INSTRUCTIONS FOR UPDATING YOUR ER

BRAIDWOOD NUCLEAR GENERATING STATION - UNITS 1 & 2

ENVIRONMENTAL REPORT - OPERATING LICENSE STAGE

This section contains the NRC request for additional information based on B. J. Youngblood's letters of September 7 and 14, 1983, followed by the response to the question. In some cases the response includes a reference to the appropriate updated sections of the text.

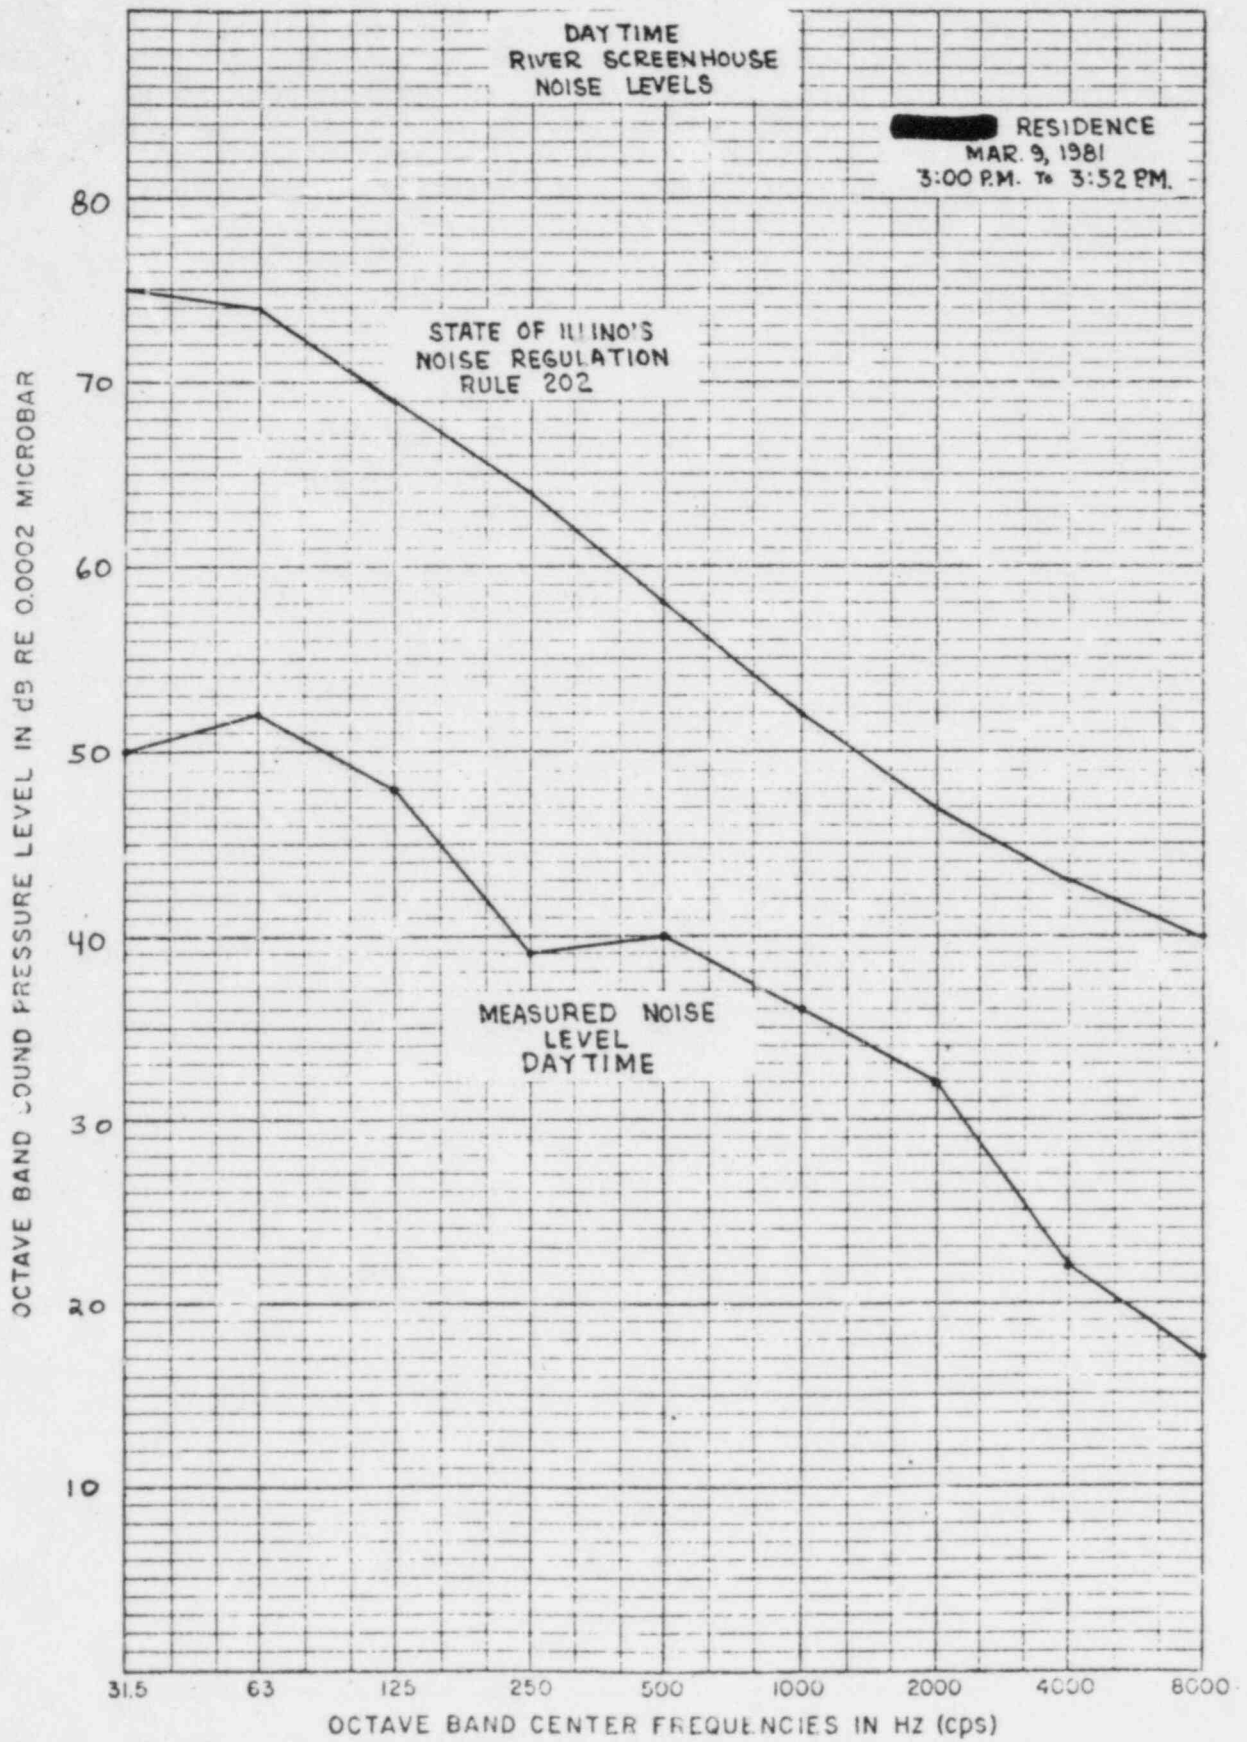
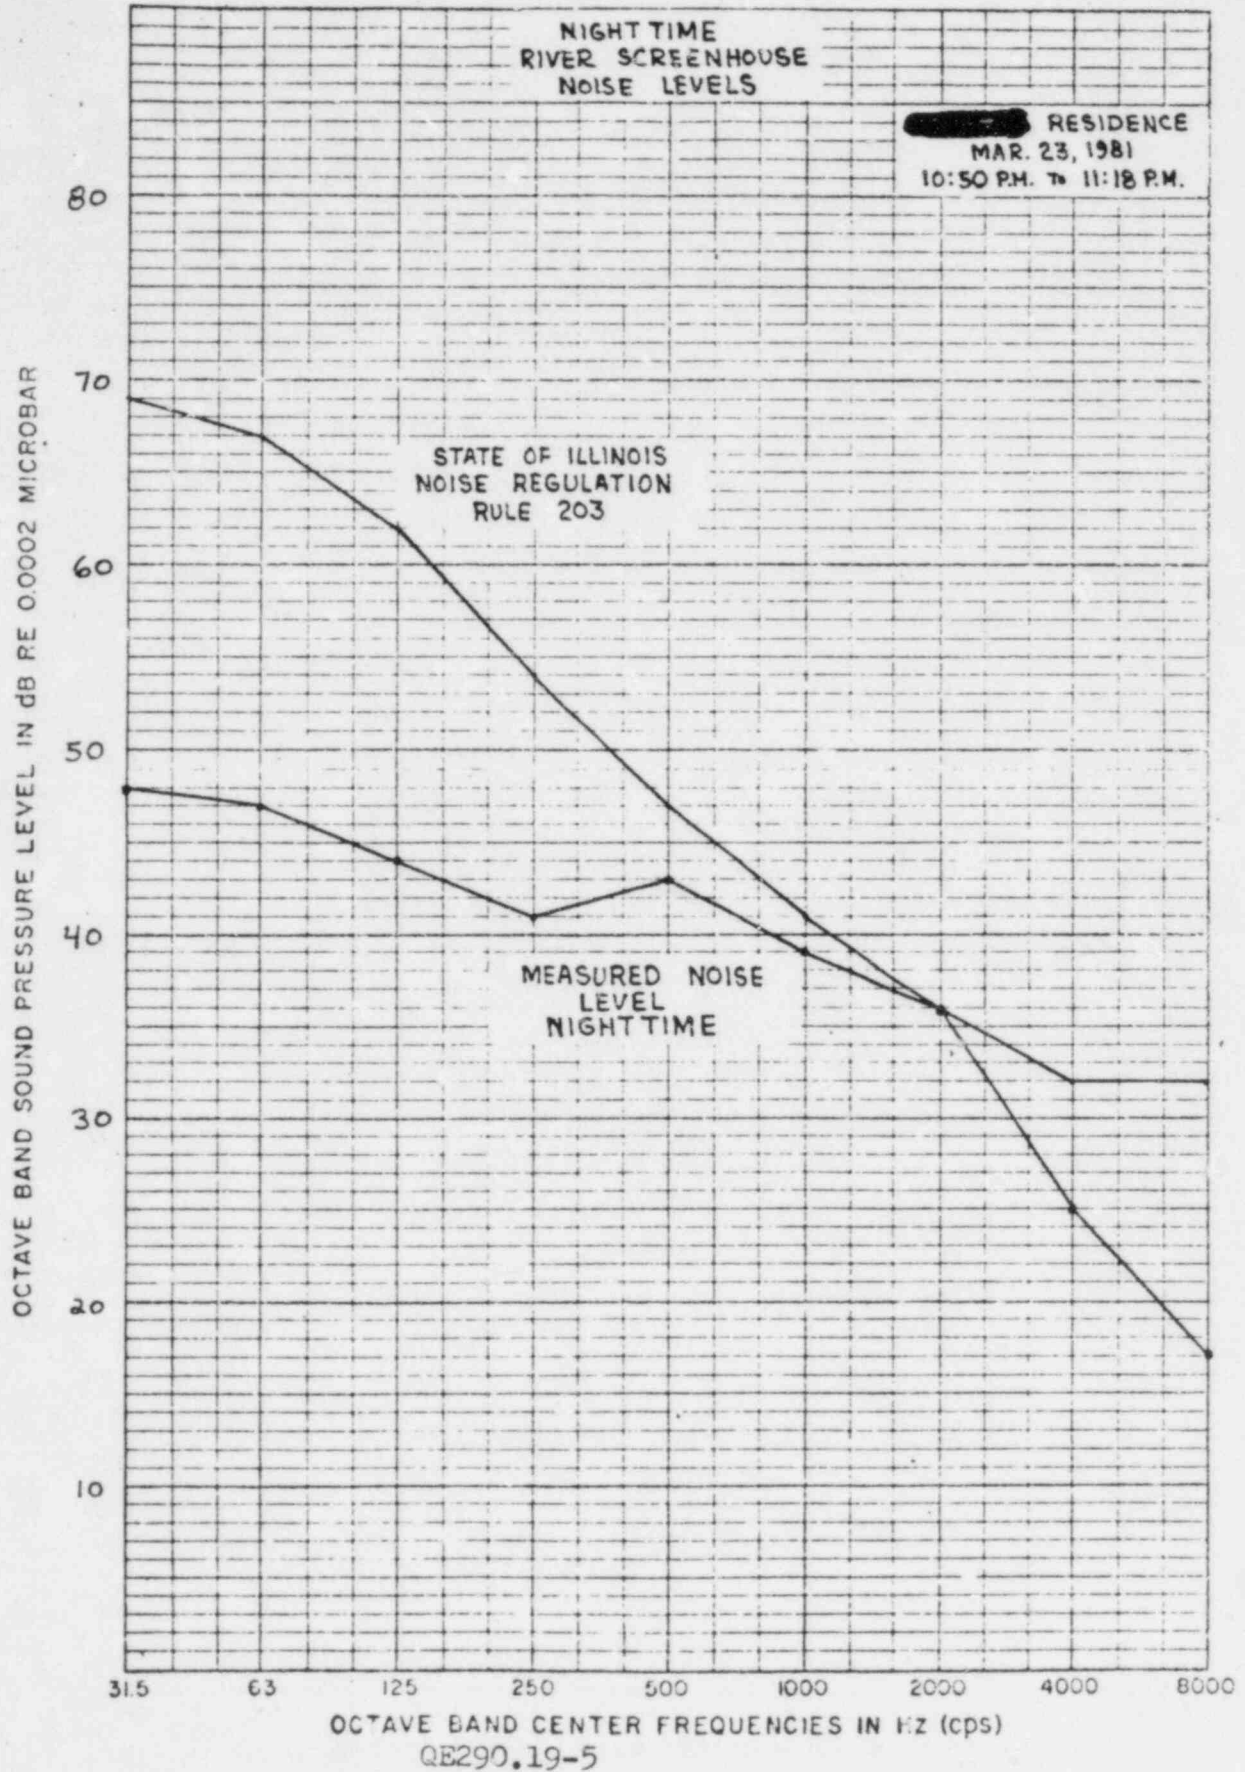
Provide a copy of the ambient and operational noise measurement studies carried out by the Applicant and done for the region near the pumphouse.

Results of our analysis yielded the following:

Daytime noise level	$Ld = 45.4$ dB
Nighttime noise level	$Ln = 44.9$ dB
Day-Night noise level	$Ldn = 51.4$ dB

DESCRIPTION DAY TIME BRAIDWOOD RIVER SCREENHOUSE

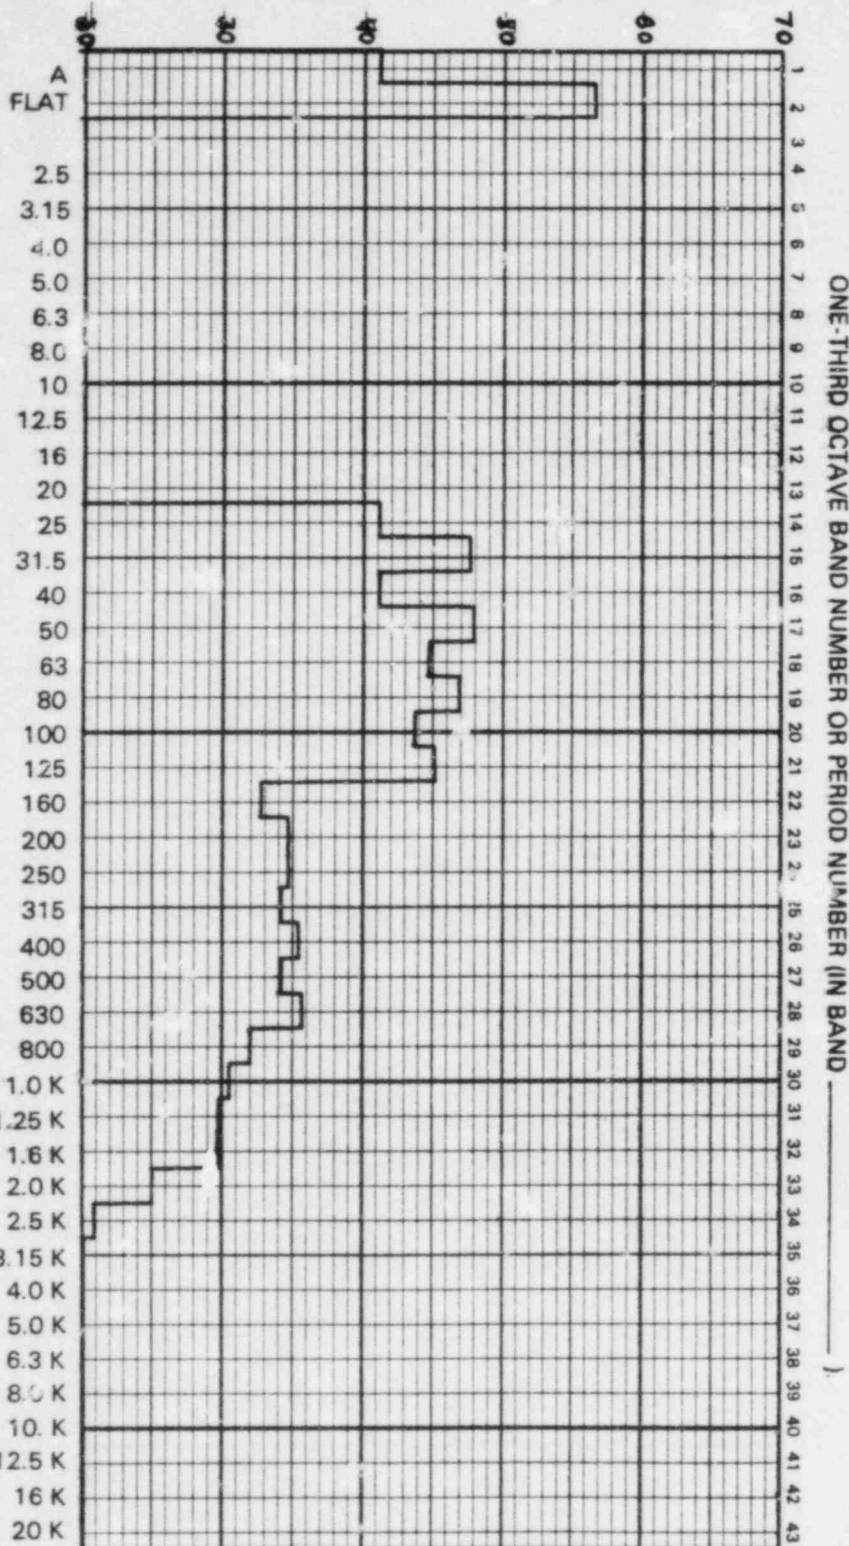
From the operational measurements made at the pumphouse site, indicate the decibel level in the 1/3-octave band containing the pump motor tone.

MEASUREMENTS TAKEN ACROSS THE RIVER AT THE
RESIDENCE 3:00 PM - 3:50 PM

TWO MAKE-UP WATER PUMPS IN OPERATION

The decibel level in the 1/3 octave band containing the pump motor tone from the operational measurements across the river with two make-up water pumps operating were:
